UNITED STATES PATENT AND TRADEMARK OFFICE

APPLICATION NO.	FILING DATE	FIRST NAMED INVENTOR	ATTORNEY DOCKET NO.	CONFIRMATION NO.
09/989,369	11/19/2001	Gregory Alan Whitlow	10541-273	1119
29074	7590	08/30/2004	EXAMINER	
VISTEON C/O BRINKS HOFER GILSON & LIONE PO BOX 10395 CHICAGO, IL 60610			FORD, JOHN K	
			ART UNIT	PAPER NUMBER
			3753

Office Action Summary	Application No. 09/989,369	Applicant(s) WHITLOW ET AL. 	
	Examiner John K. Ford	Art Unit 3753

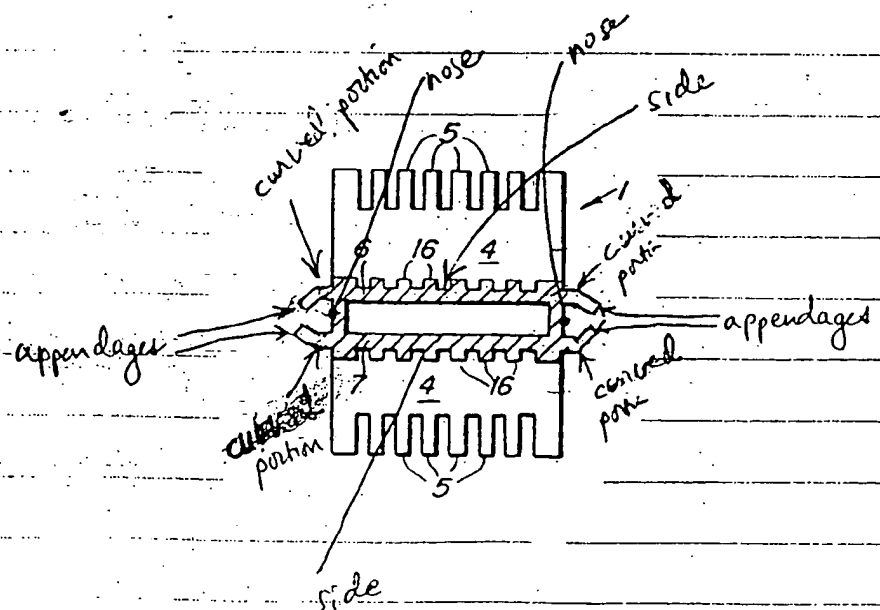
Claims 2, 4, 8-11, 16, 18, 25-28 and 32-35 are rejected under 35 U.S.C. 103(a) as being unpatentable over the combined teachings of O'Connor and Yoshii et al (5,653,283).

O'Connor shows straight "appendages" at each end of the tube which project outwardly parallel to major cross-section axis of the tube. To have curved each of these projections in O'Connor towards one another as taught by Yoshii Figure 1 at "4f" would have been obvious to improve air flow as discussed in col. 5, lines 5-10, by making the transition less abrupt than a blunt end would be. Such an improved curving of airflow would advantageously reduce the airside pressure drop through the heat exchanger.

The modification is shown below

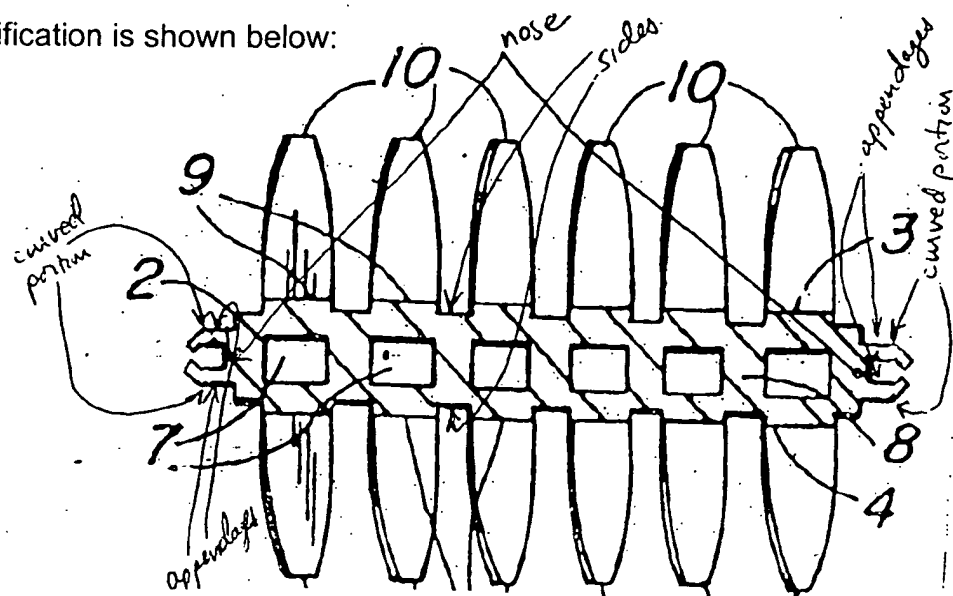
Claims 3, 4, 8-11, 16, 18, 25-28 and 32-35 are rejected under 35 U.S.C. 103(a) as being unpatentable over the combined teachings of DT'069 and Yoshii et al. (5,653,283).

DT'069 shows straight "appendages" at each^{end} of the tube which project outwardly parallel to major cross-sectional axis of the tube. To have curved each of these projections in DT'069 towards one another as taught by Yoshii Figure 1 at^{4f} would have been obvious to improve air flow as discussed in col. 5, lines 5-10, by making the transition less abrupt than a blunt end would be. Such an improved curving of the

airflow would advantageously reduce the air-side pressure drop through the heat exchanger. The modification is shown below:
